# Addendum No. 1

## CSI Diesel Mechanics Facility

## Addendum 1

Project: CSI: Automotive/Agricultural Diesel Mechanics Facility

**DEMOLITION PLAN**

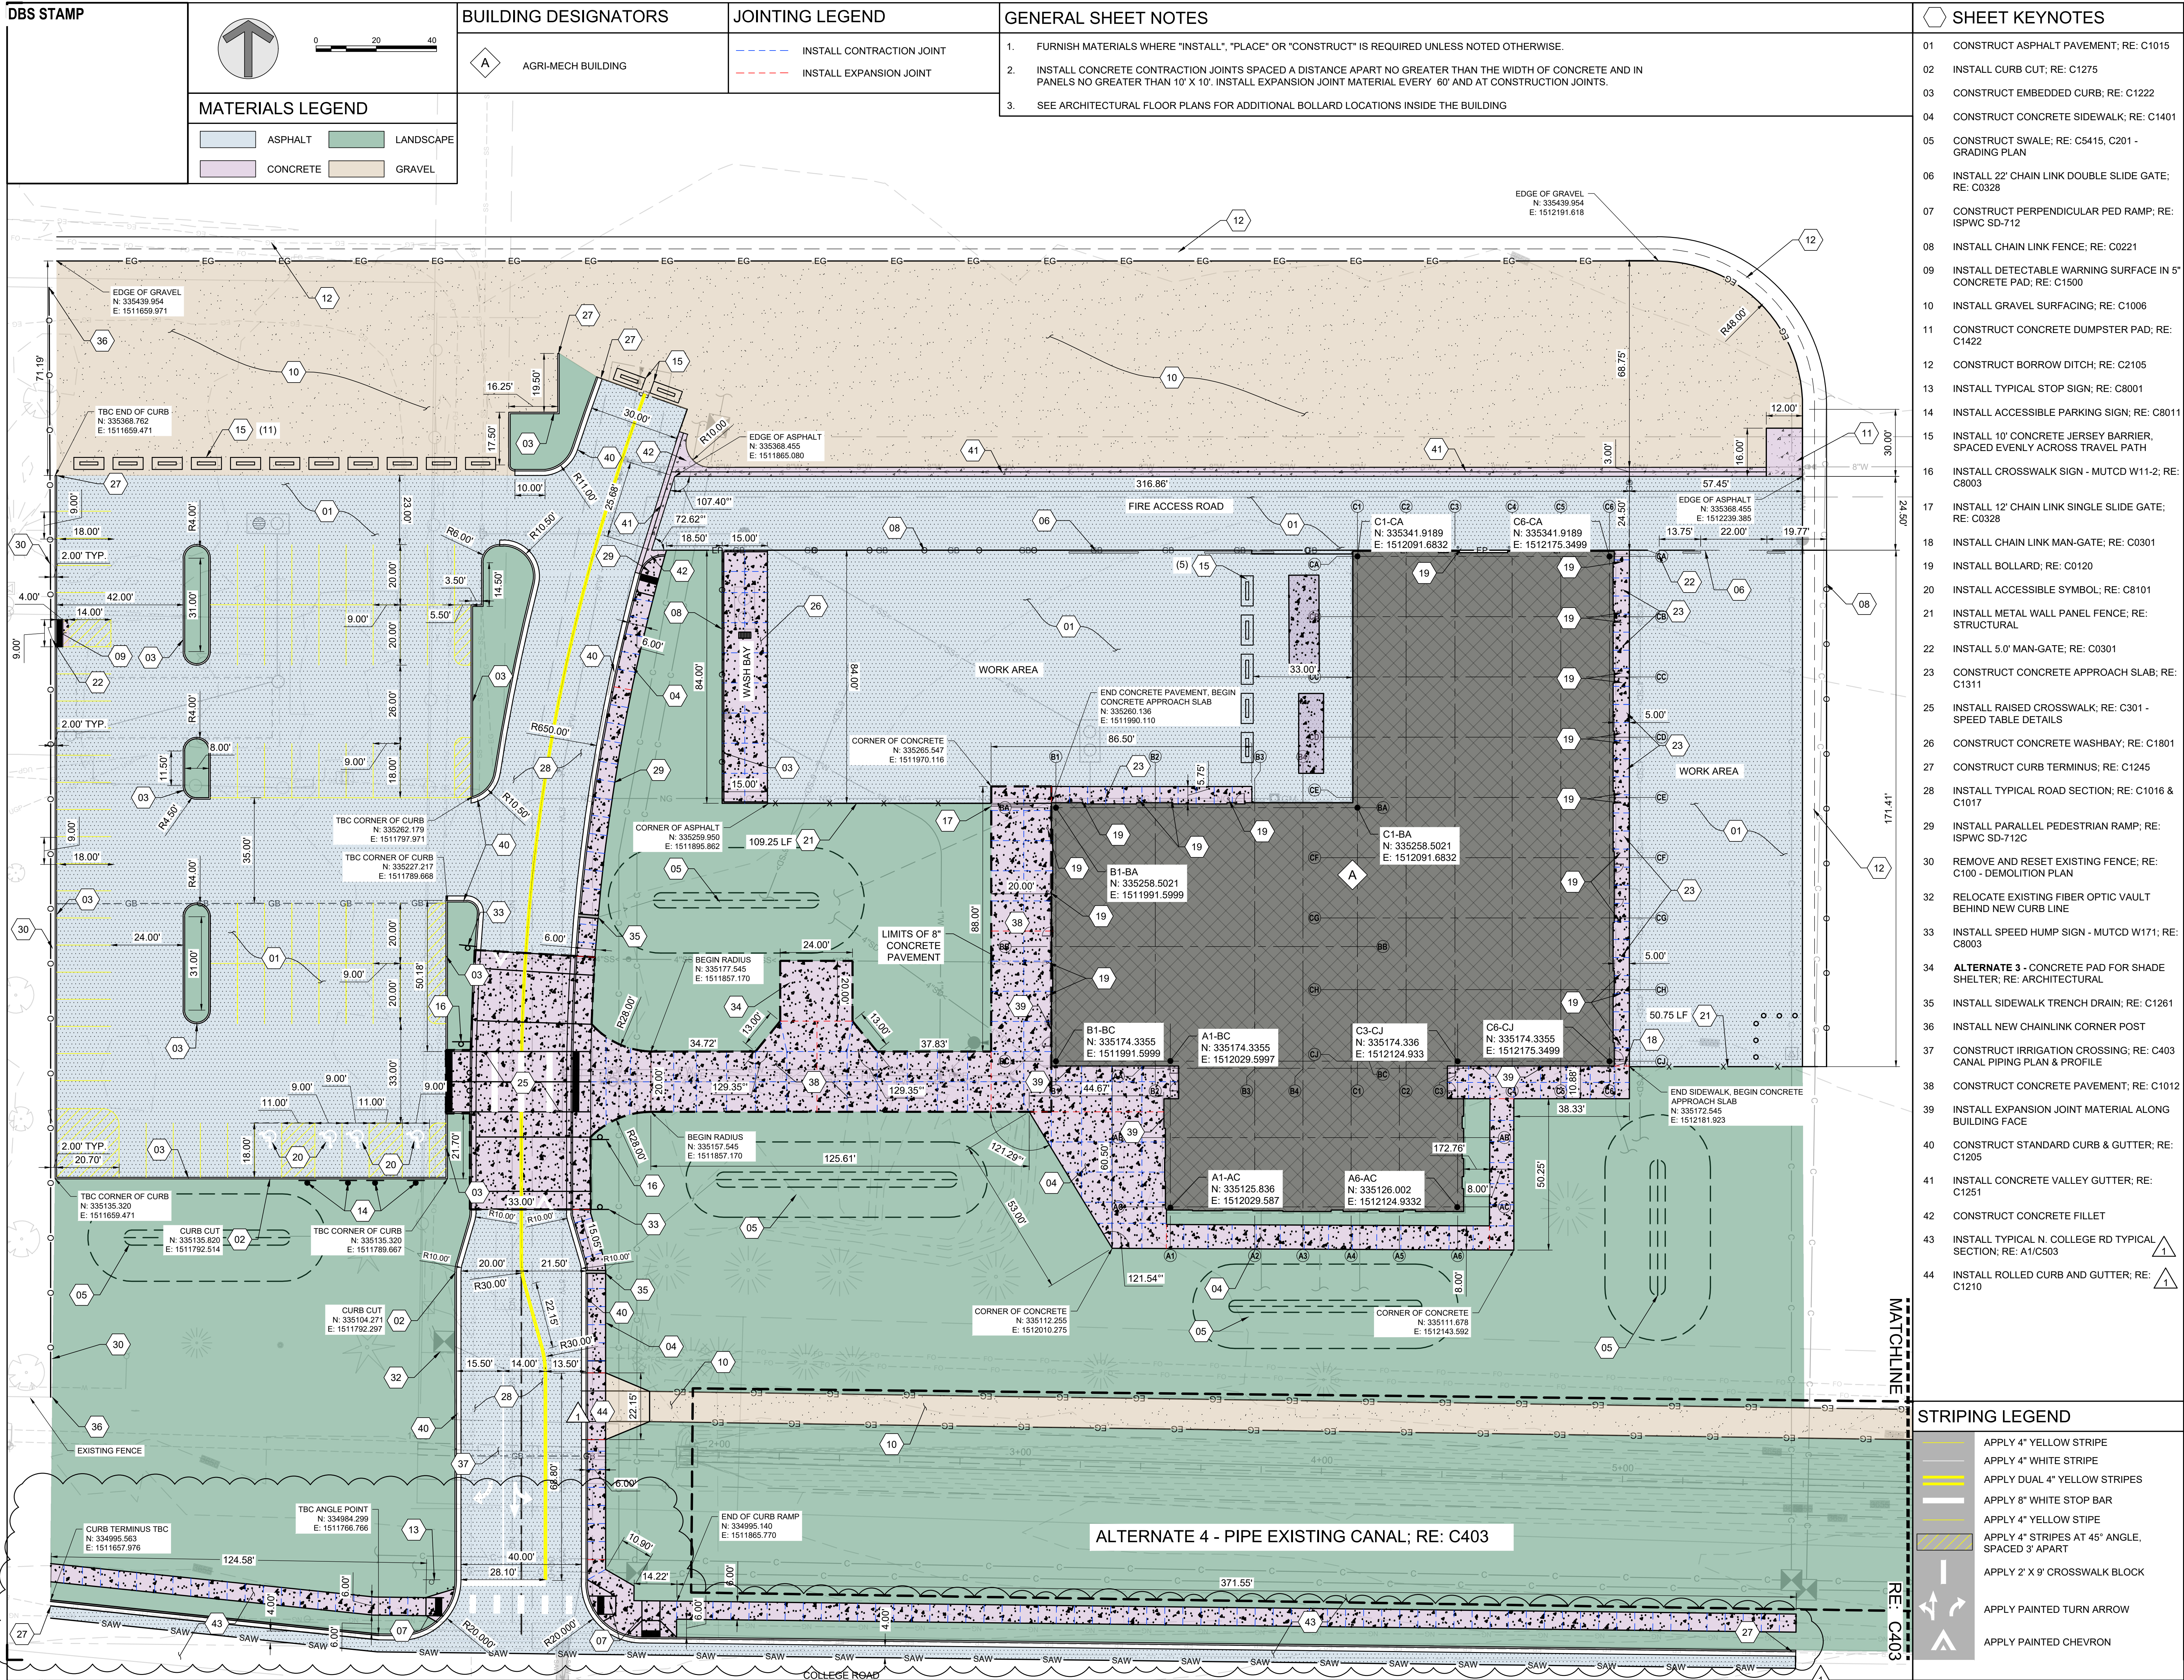
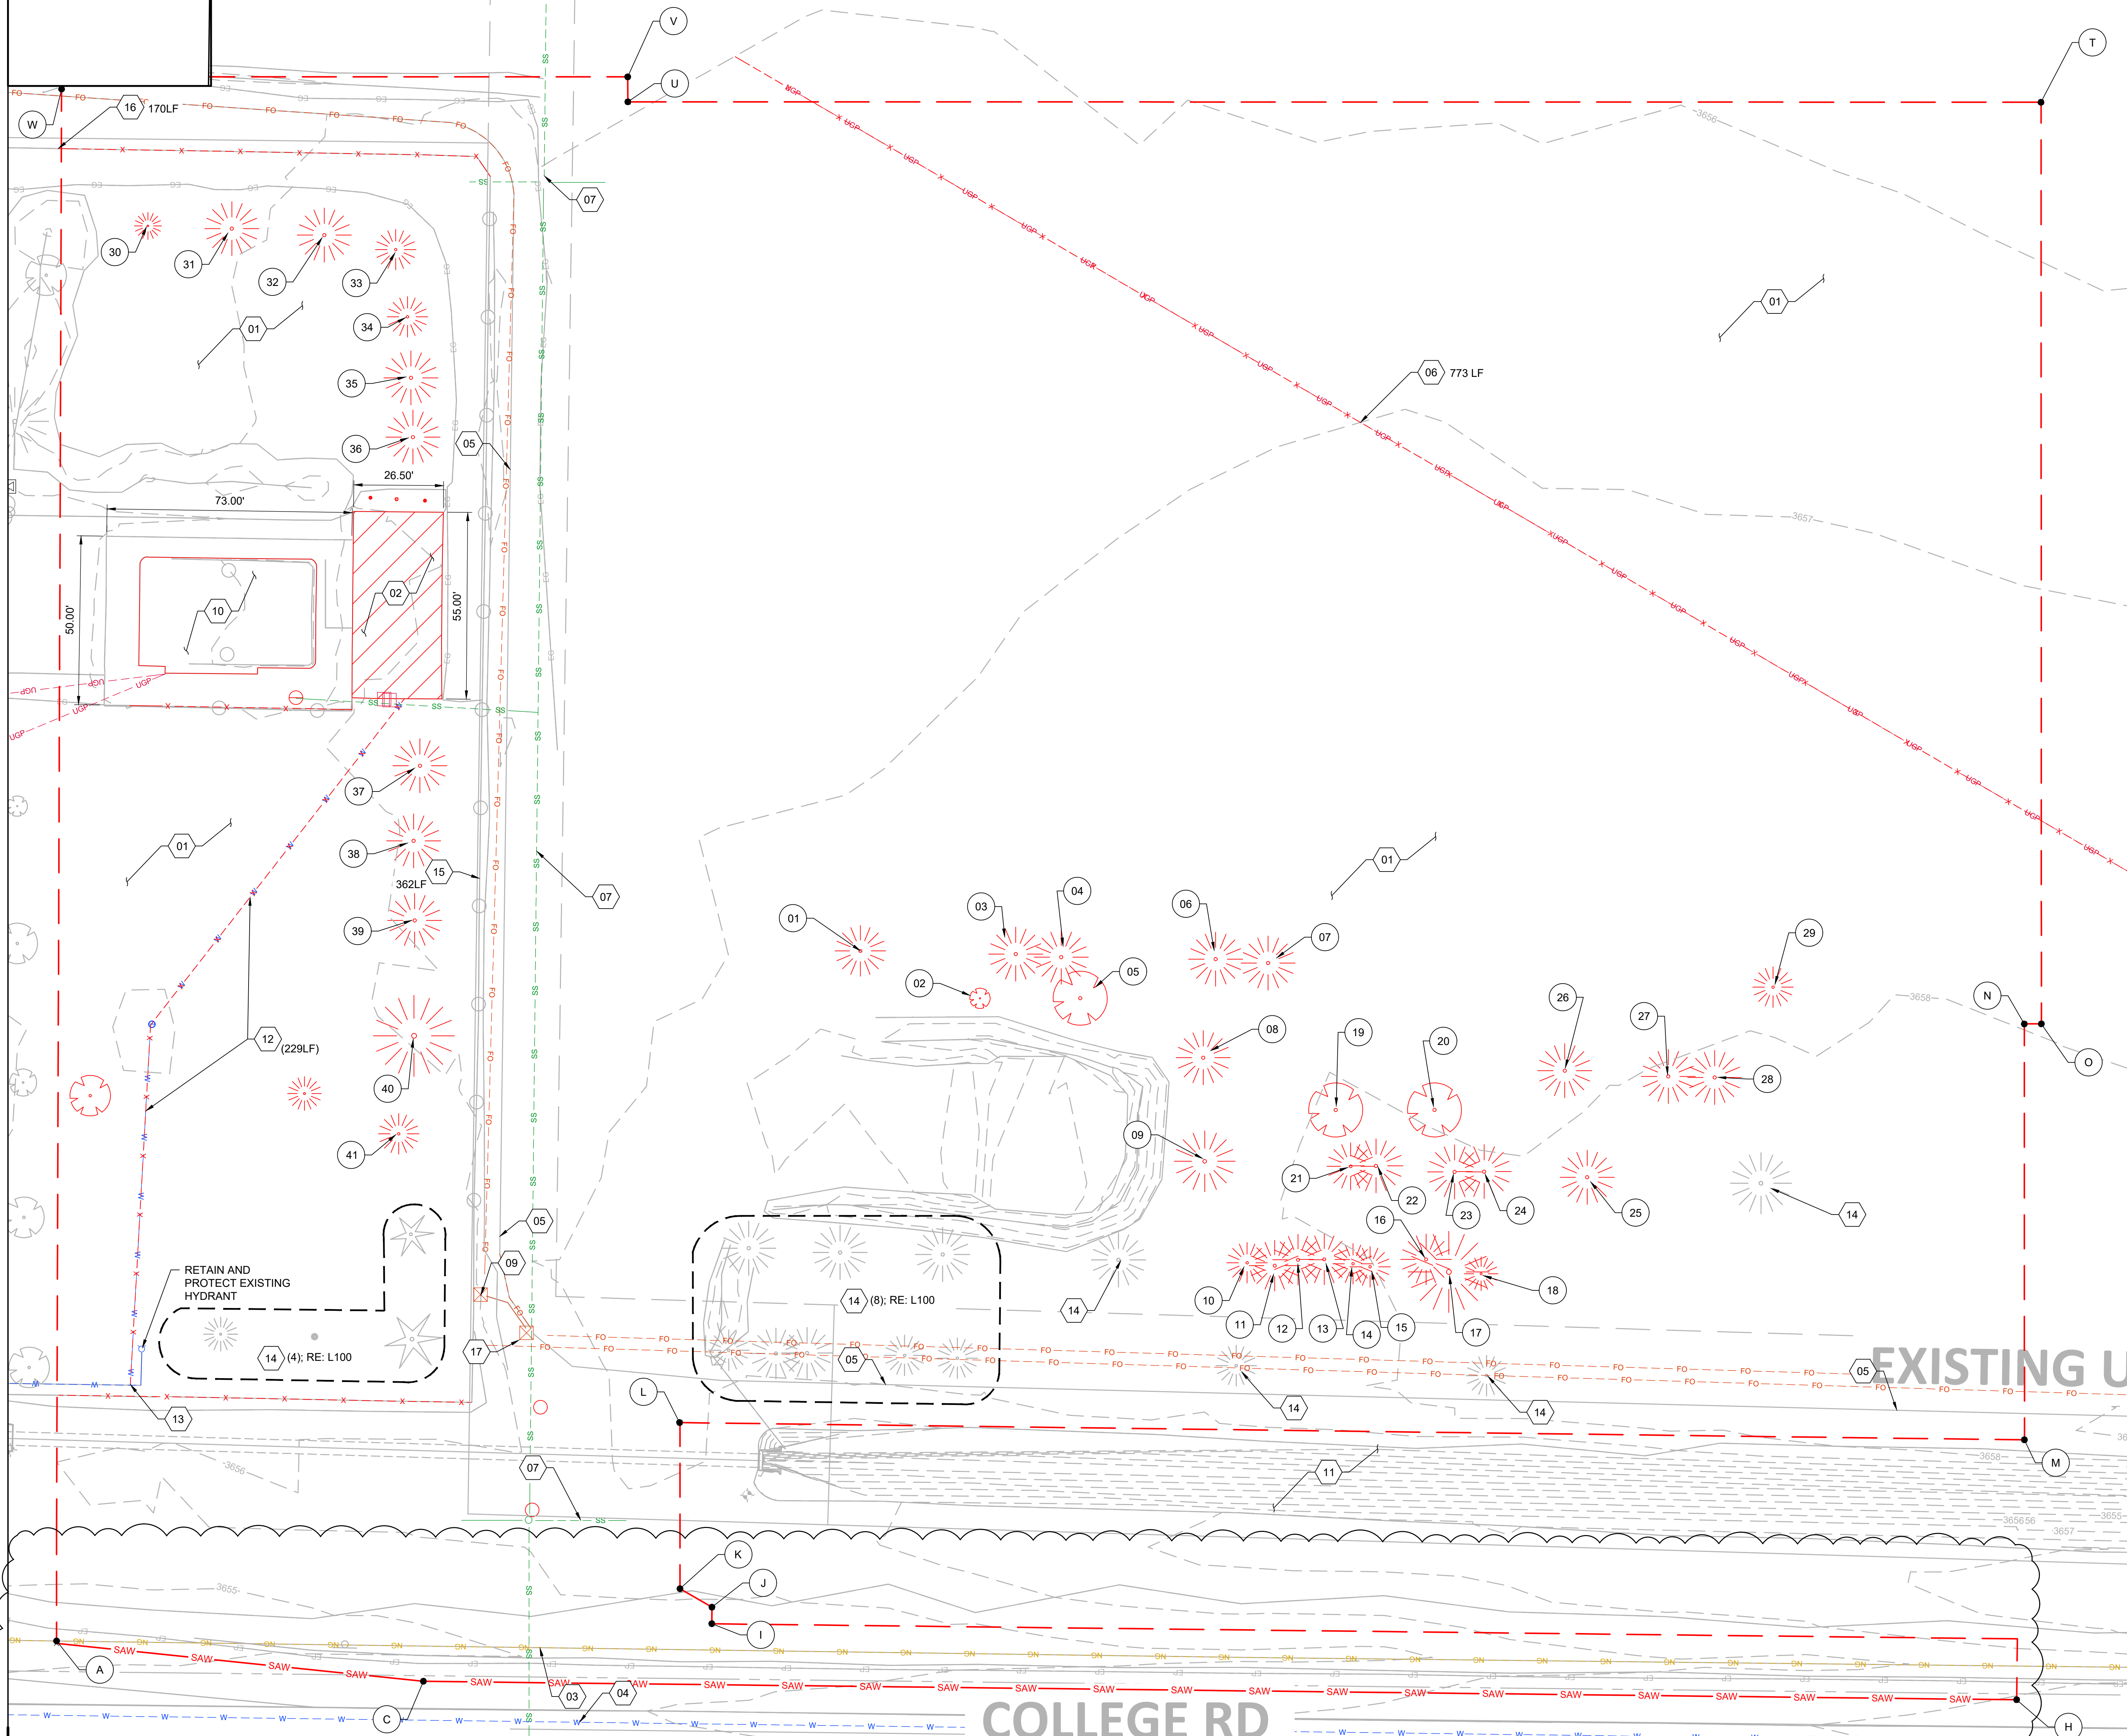
Item #C1      C100 – DEMOLITION PLAN  
 Add. #1      Demolition/clear & grub limits adjusted to include city frontage improvements.

GRADING PLAN

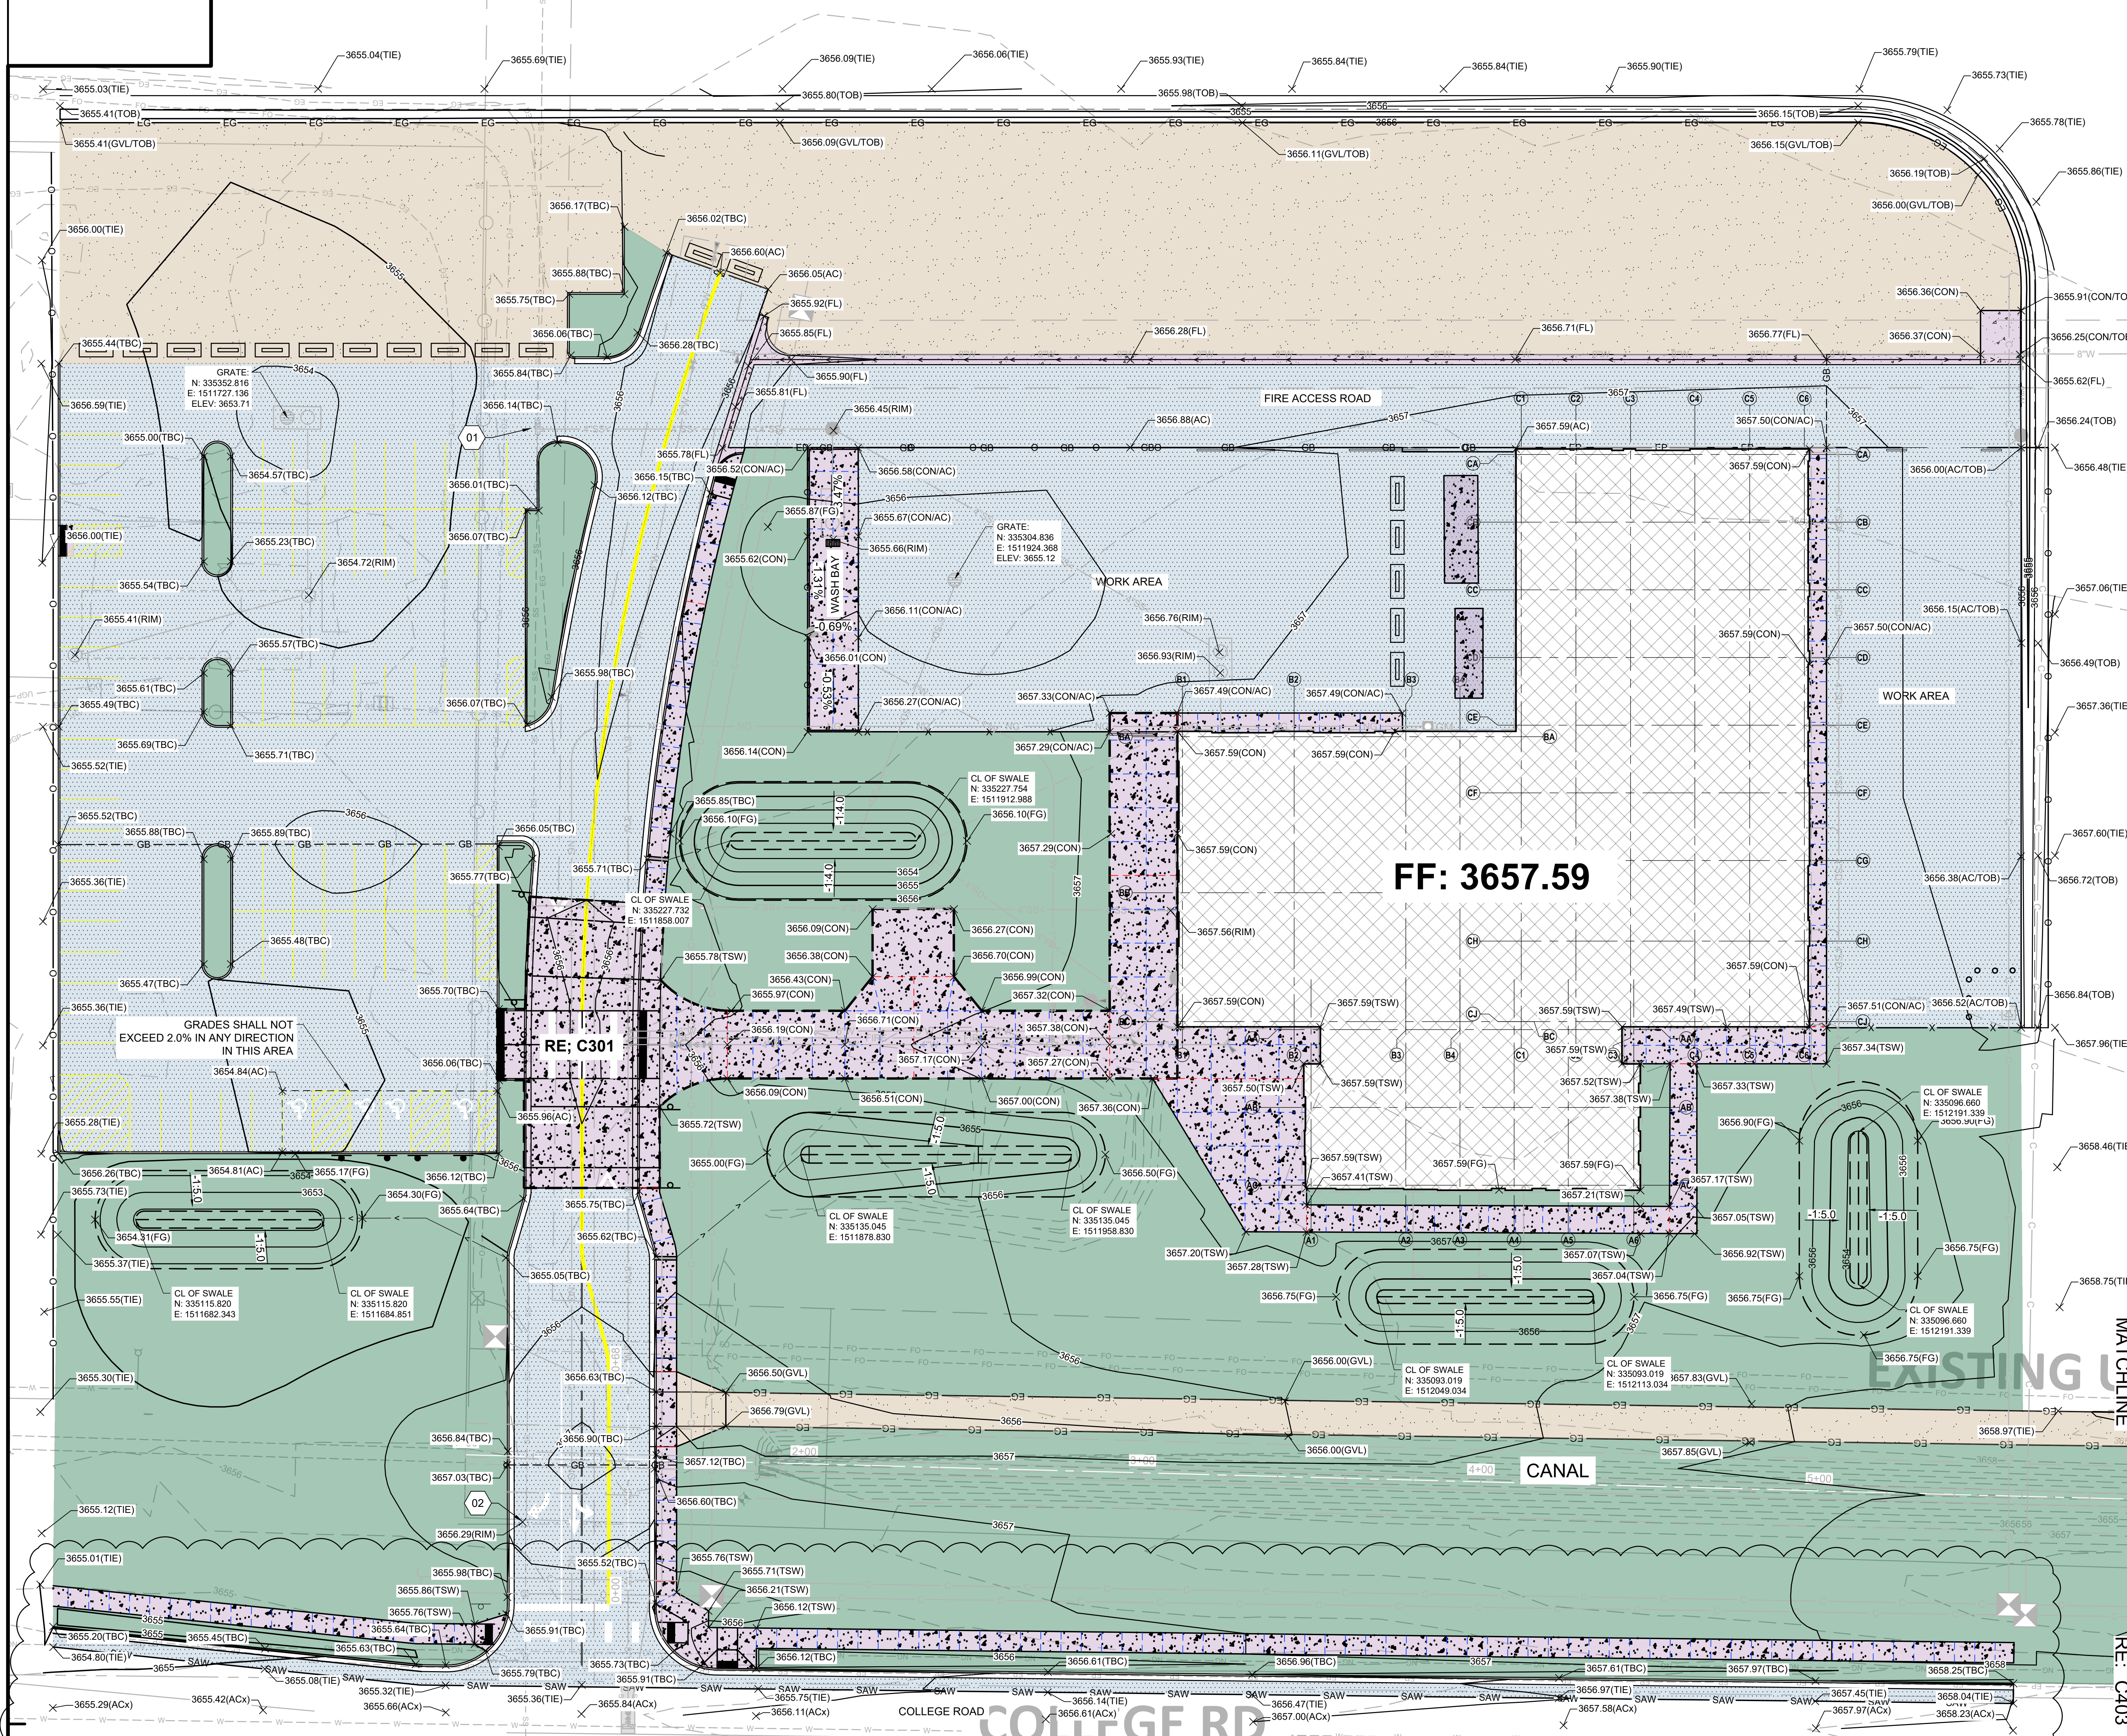
Item #C3      C201 – GRADING PLAN  
 Add. #1      A. Acronym TOB has been revised to read “top of bank”.  
                   B. Grading updated to include city frontage improvements.
